ADDENDUM No. 5 – February 16, 2022

PART 1 - GENERAL

REFERENCE: H4.1
 DRAWING TITLE:
 Partial Ground
 Level HVAC
 Piping Plan
 Section B

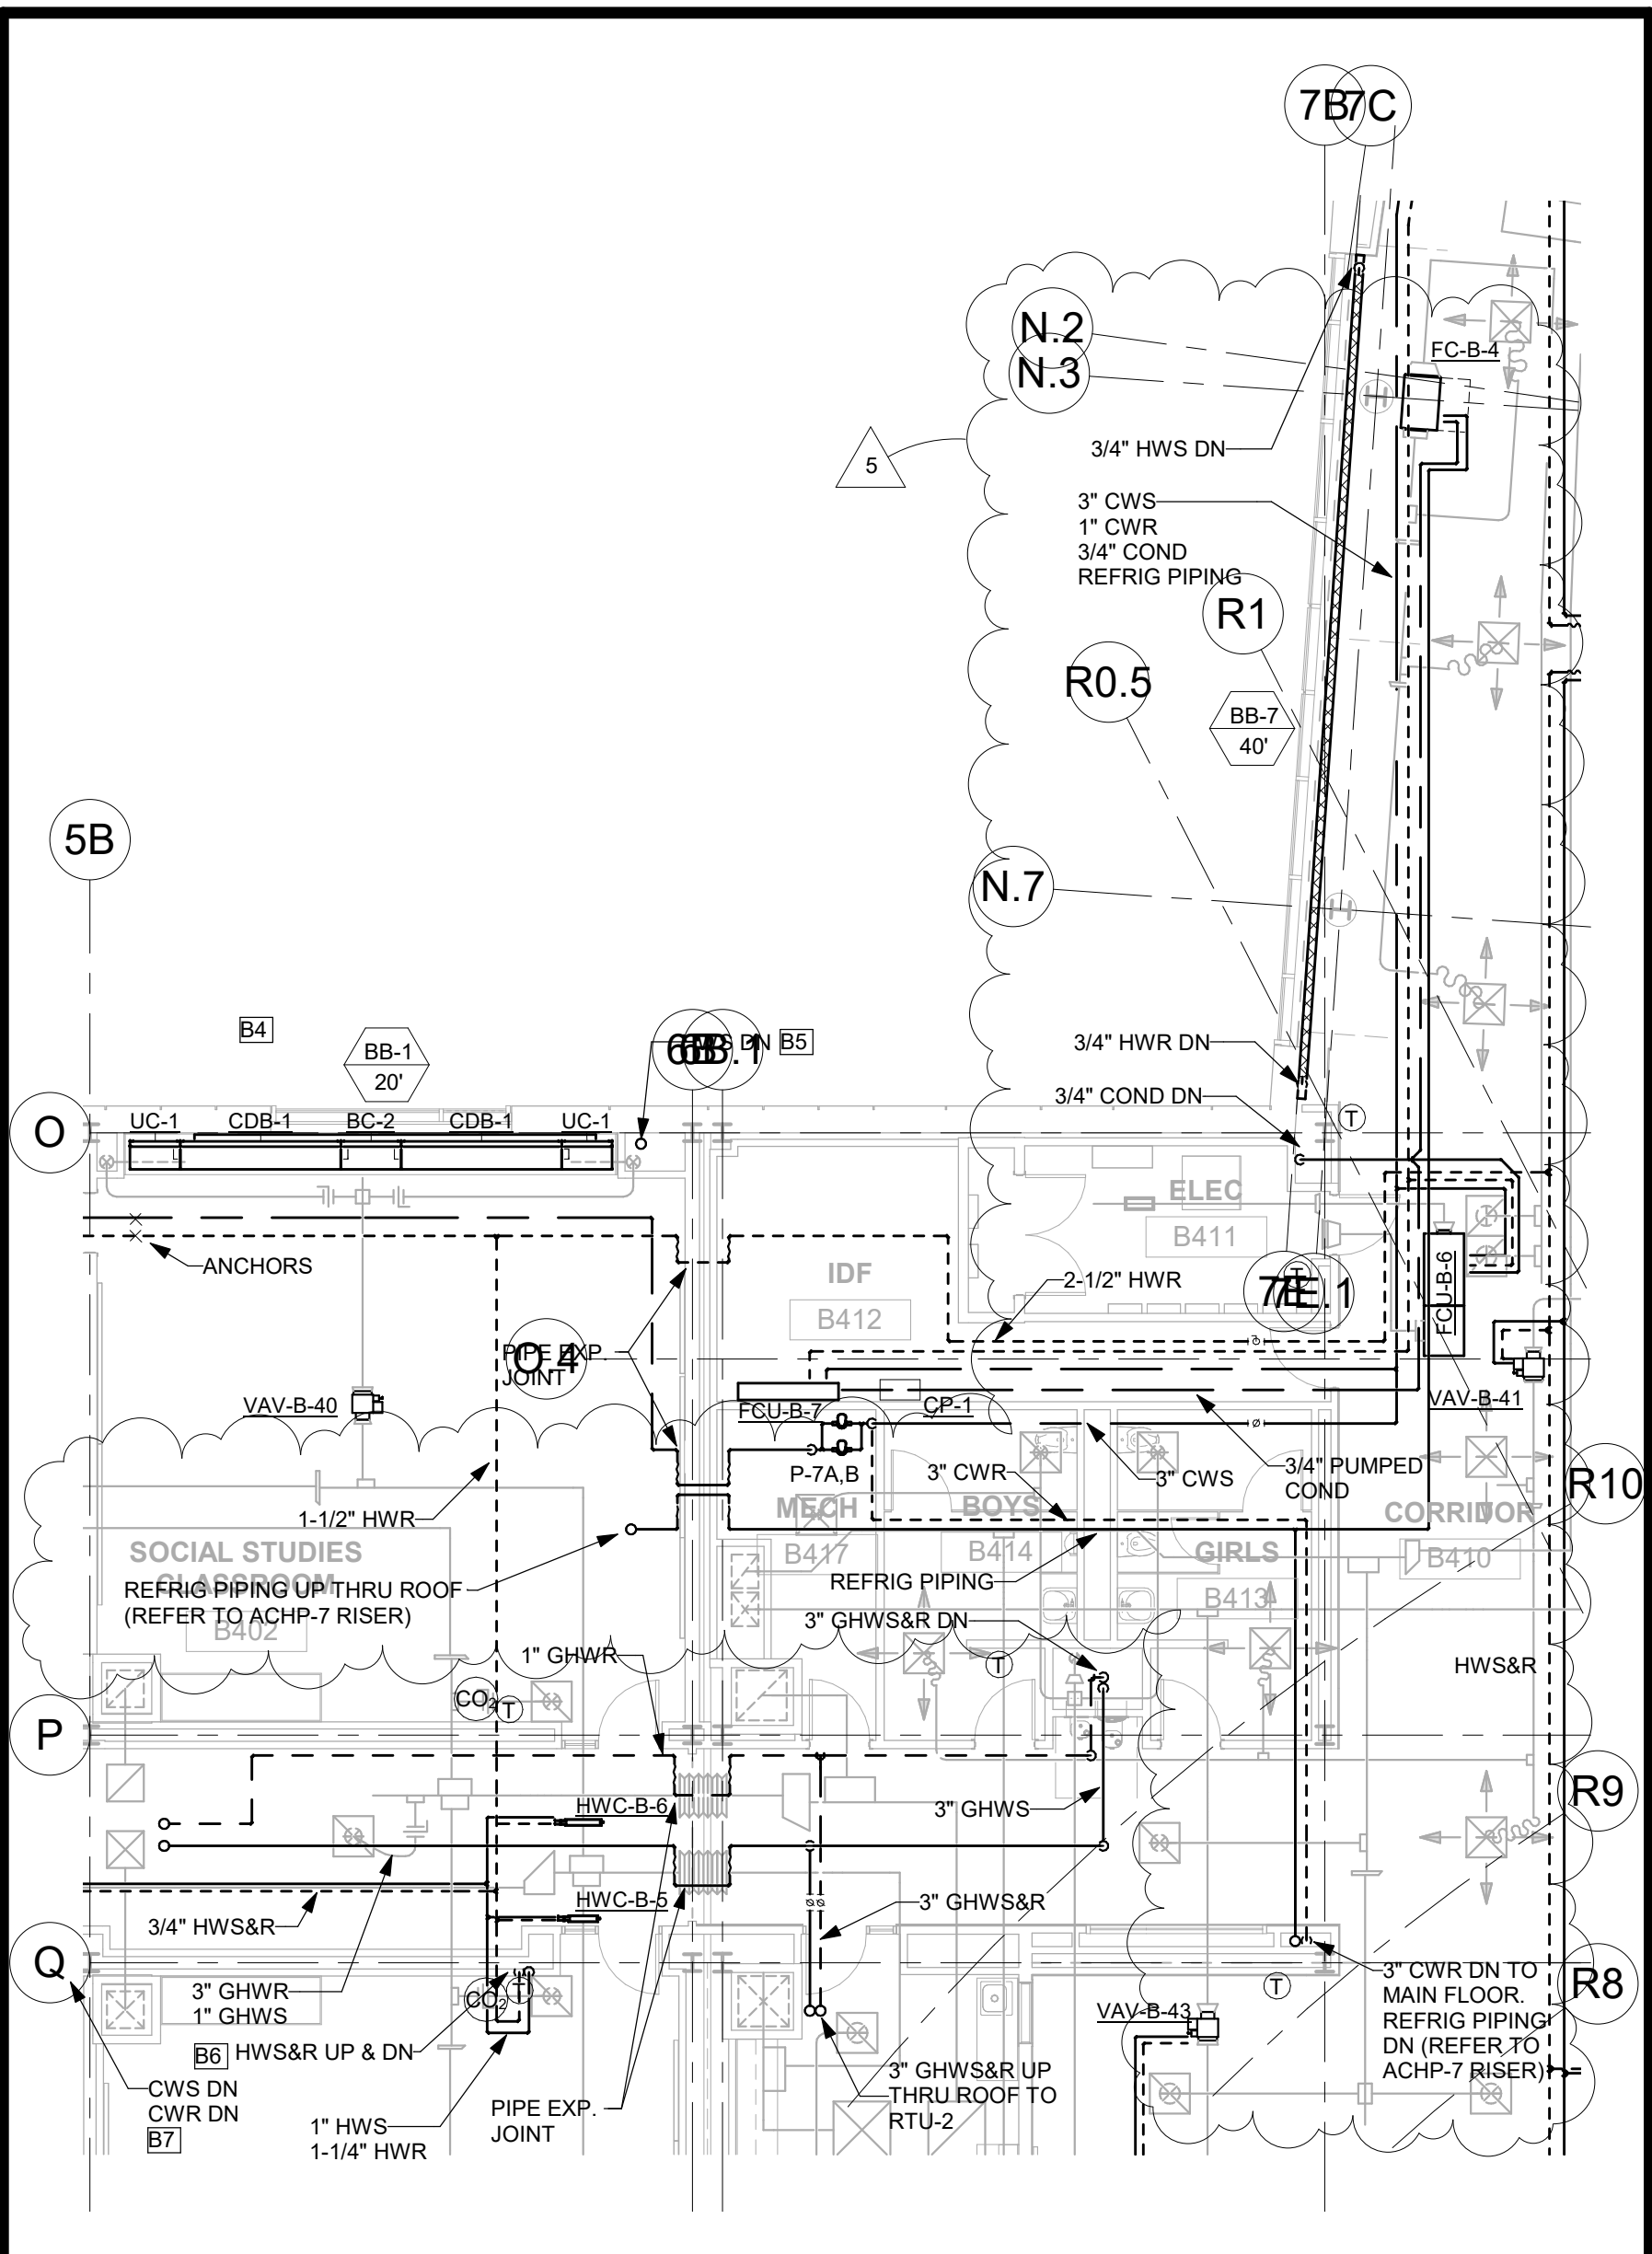
- A. In room A007 replace 24 feet of BB-1 with 18 feet of BB-2.
- B. In room A015 change BB-3 to BB-6.
- C. Tag fan coil unit in corridor A000 near column line X-2A as FCU-A-8.
- D. Provide thermostats in the following additional areas: A011, Stair A1.0 (near column line T.2-2A), Stair A2.0 (near column line X.9-6.1A), A000 (near column line V-2A), B002, B005 (near column line S-4B), B005 (near column line O-4B), B007, B008, B013, B017, E000 (near column line S-7B), E060 (near column line S.3-8B),
- E. Refer to ADD-5/H025 Partial Ground Level HVAC Piping Plan Section B attached.
